# COMMUNITY DEVELOPMENT DEPARTMENT REPORT

HEARING DATE: April 2, 2026  
*Continued from: 12/18/2025, 2/5/26 & 2/19/26*

TO: Planning & Zoning Commission

SUBJECT: H-2025-0007  
Syringa Crossing Mixed-Use Development (aka Hawkins Syringa Crossing Subdivision) – AZ, CUP, PP

### FA3. Mixed Use Community Concept Color Diagram with Markup

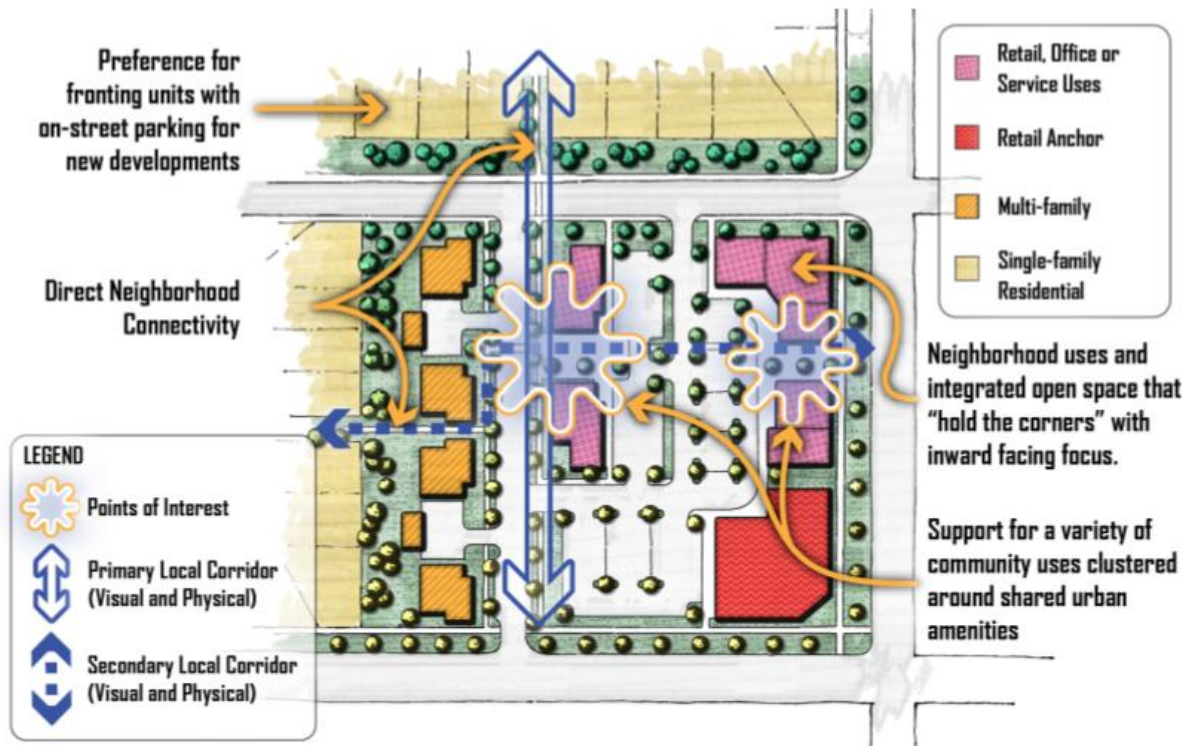
Development review for consistency with the Comprehensive Plan will consider the integration of use and holistic design sub-sections (below) in all mixed-use areas unless otherwise noted. To be successful, the principles outlined must be considered as interrelated features serving the basis of plan design. **Contiguous Mixed Use identified areas that are bisected by an arterial or highway are considered separate and independent areas for use and design integration and will be evaluated independently of each other per the Plan (pp. 3-14 & 3-16).**

### E. Conceptual Development Plan for Annexation Area (dated: 1/6/26) - *REVISED*

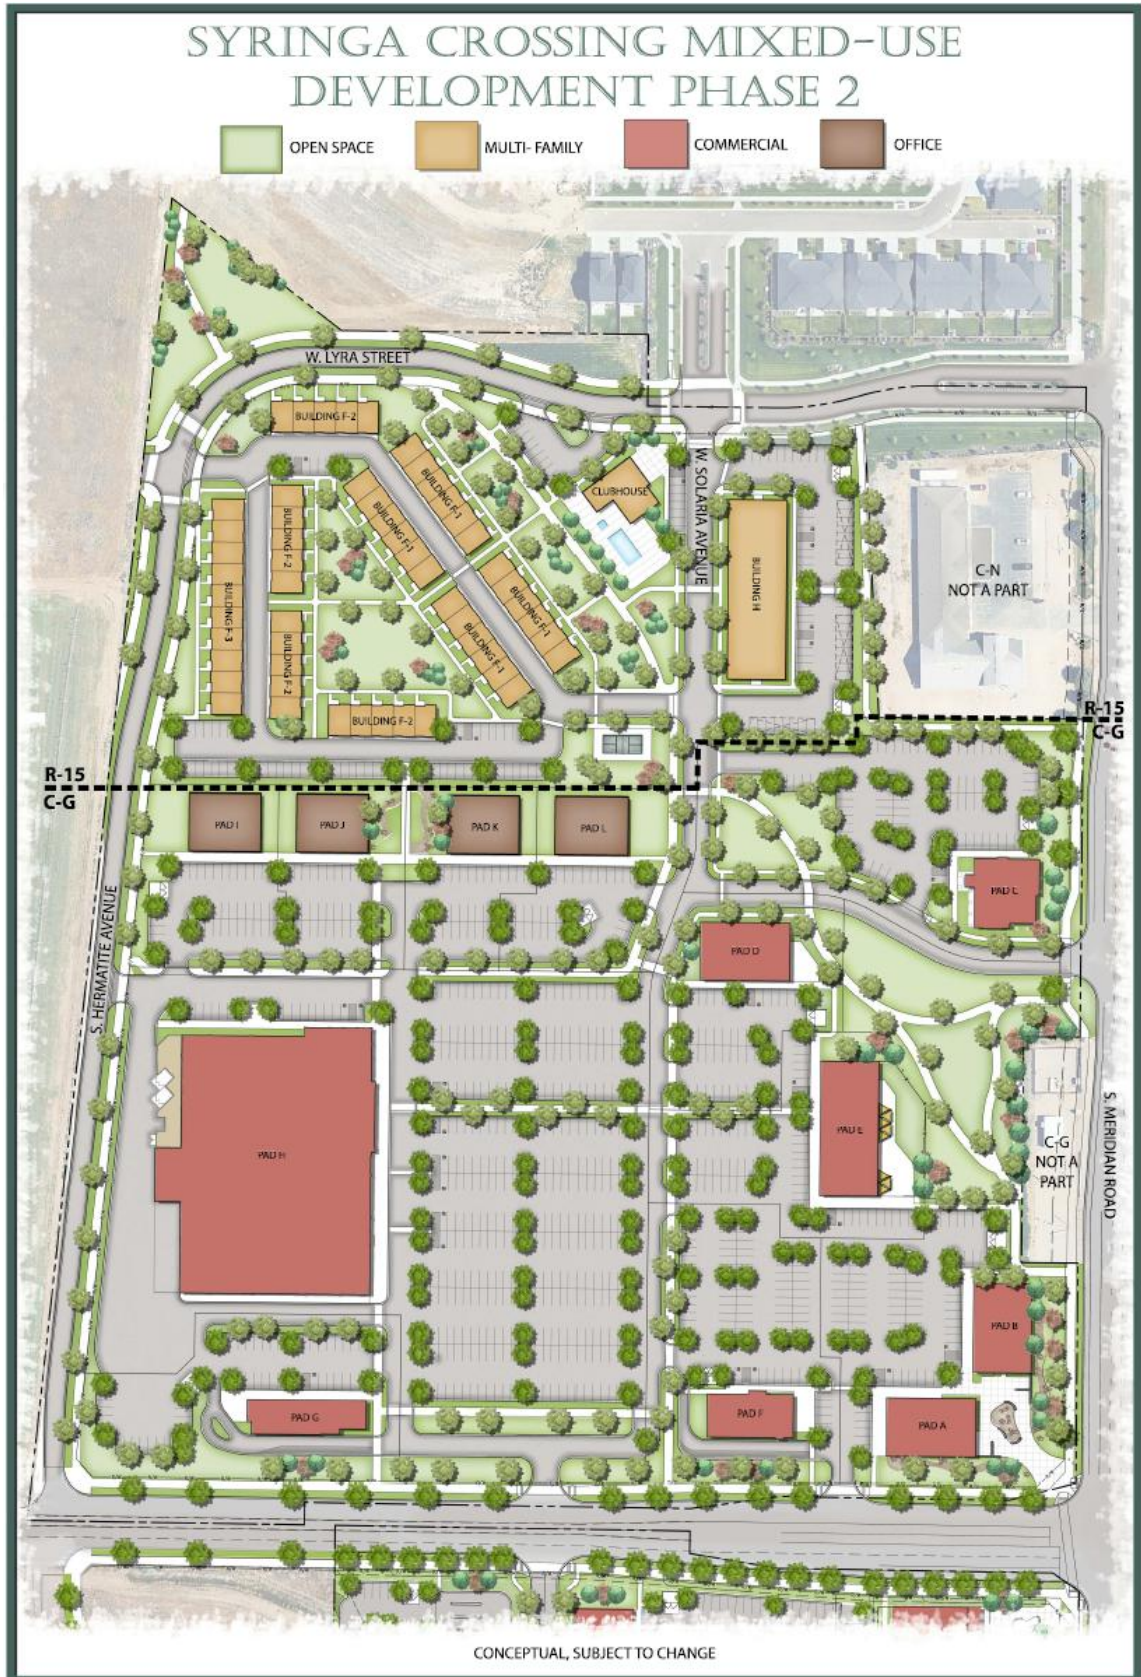
The conceptual development plan depicts two (2) driveway accesses via W. Amity Rd. as well as a collector street (S. Hermatite Ave.) access at the west boundary of the site in accord with the MSM; one (1) driveway access via S. Meridian Rd./SH-69; two (2) accesses via W. Lyra St., a collector street; and two (2) accesses via S. Hermatite Ave., a collector street. South Solaris Ave. is proposed to extend into the site 45’ from the north property line.

**The access points depicted on the conceptual development plan are not approved and should be evaluated with a future subdivision application.**

The conceptual development plan depicts one (1) driveway access via W. Amity Rd. and one (1) driveway/private street access via S. Meridian Rd./SH-69. A portion of a future collector street (Hermatite) via W. Amity Rd. is depicted along the southern portion of the west boundary of the site and stubs to the property to the south – the portion that connects to Amity Rd. is off-site on the adjacent property to the west and is not proposed to be constructed with this development. **The collector street access is needed for emergency service providers to adequately provide service the multi-family development; therefore, the collector street should be extended from W. Amity Rd. to the site prior to issuance of the first Certificate of Occupancy within the multi-family development.** Two (2) access driveways are proposed via Hermatite in the multi-family development.
